#### 174th session

## **Proposal for Supplement 4 to the 02 series of amendments to UN Regulation No. 90 (Replacement braking parts)**

## **Supplement 4 to the 02 series of amendments to UN Regulation No. 90 (Replacement braking parts)**

**Figure 1**

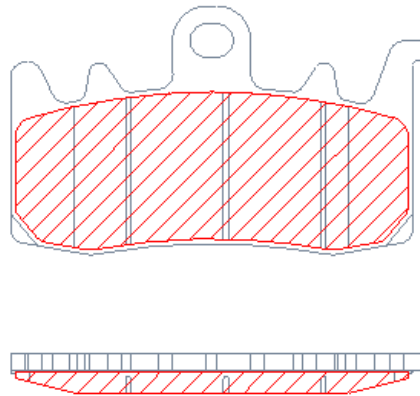
Friction material area means all the area enclosed within the perimeter of the brake lining (see the red cross-hatched area, Figure 1), thus excluding the presence of any grooves and/or chamfers:
